Project: IEEE P802.15 Working Group for Wireless Personal Area Networks (WPANs)

Submission Title: [Some issues and suggestions on light dimming in D1 draft of TG7]

Abstract: [This document describes some issues and suggestions on light dimming in D1 draft of TG7.]

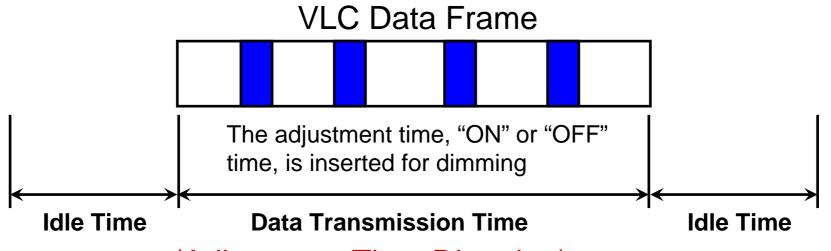
The dimming on idle time can be supported by one of 5 techniques described in clause 5.5.3.2 or their combinations which shall support non-inter-frame flicker as well as non-intra-frame flicker.
